## **SPRINGHILL MEMORIAL GARDENS SUBDIVISION,** **RESUBDIVISION OF LOTS 1 & 2**

APPLICATION NUMBER 4 DATE November 5, 2009

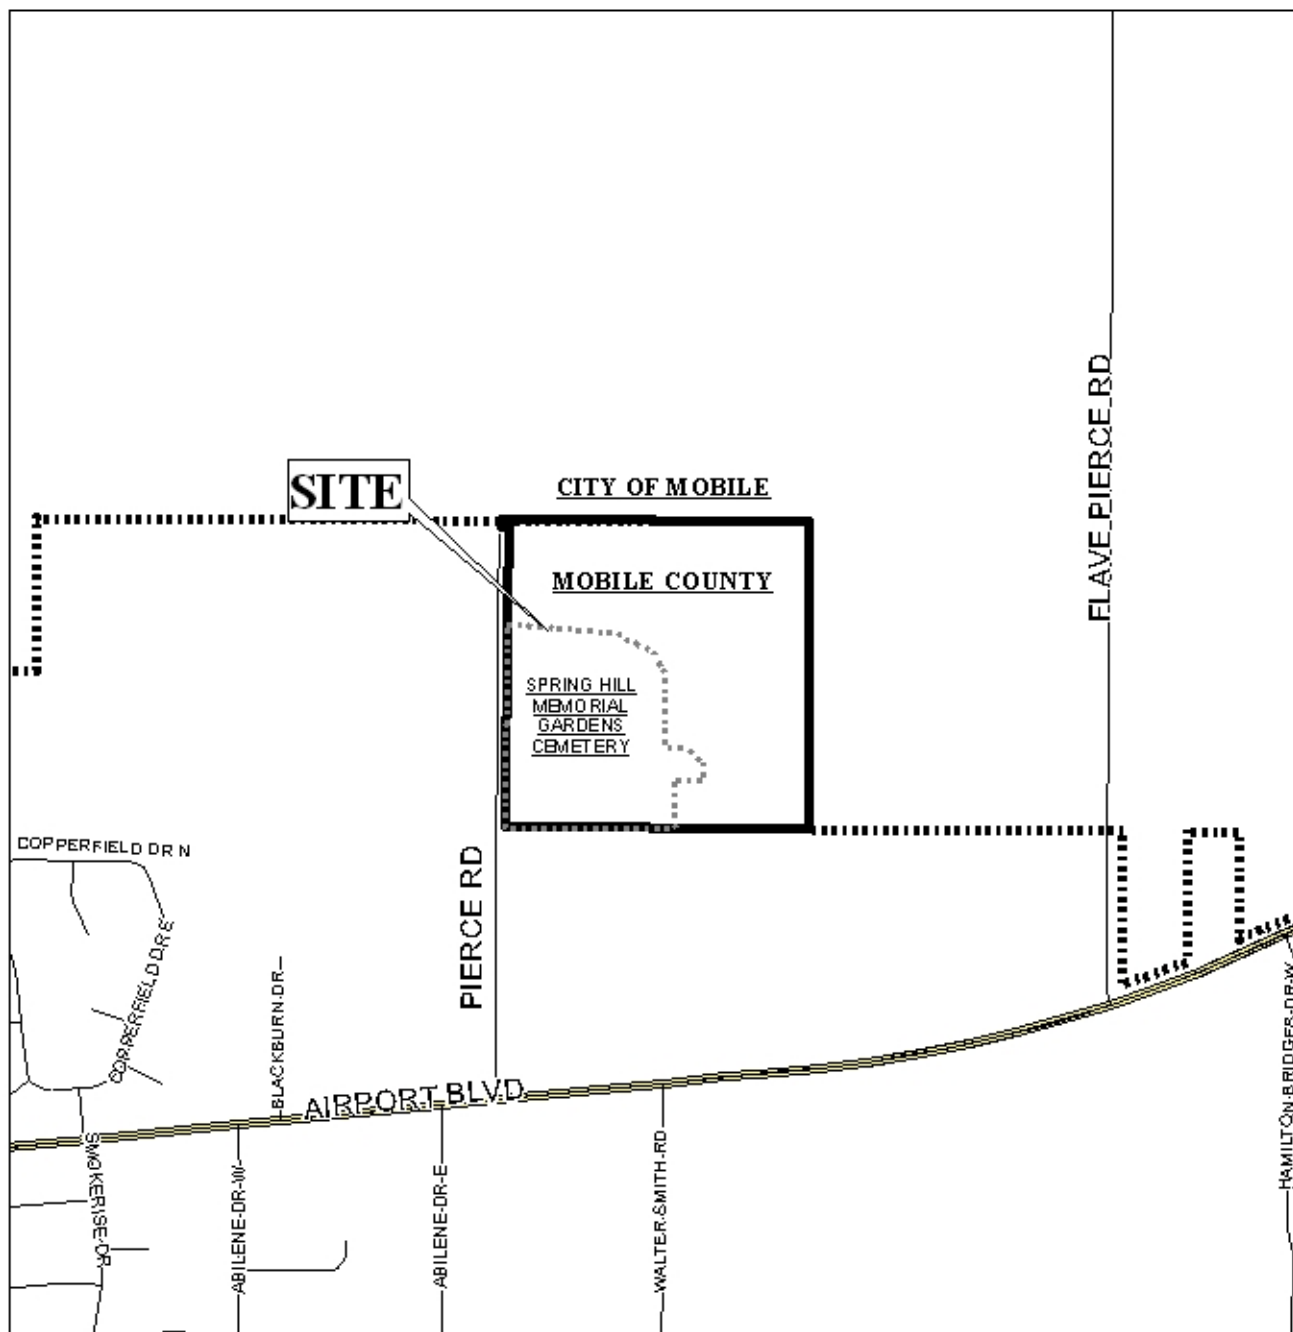
The subdivision has approximately 1,328' of frontage along Pierce Road. The cemetery currently has one curb cut to Pierce Road. As a means of access management, a note should be placed on the final plat stating that the subdivision is limited to two curb cuts to Pierce Road, with the size, location, and design to be approved by County Engineering and in conformance with AASHTO standards.

The 25-foot minimum building setback line is depicted on the preliminary plat and should be retained on the final plat, if approved.

The plat does not include a note stating lot size. The final plat should indicate lot size in square feet and acres, if approved.

- 1) Placement of a note on the final plat stating that the lot is limited to two curb cuts with the size, location and design of all curb cuts to be approved by the Mobile County Engineering Department;

- 2) Retention of the 25' minimum building setback line along Pierce Road;
- 3) Placement of a note on the final plat stating that development of the site must be undertaken in compliance with all local, state and Federal regulations regarding endangered, threatened or otherwise protected species;

- 6) Revision of the plat to label the lot with its size in square feet and acres.
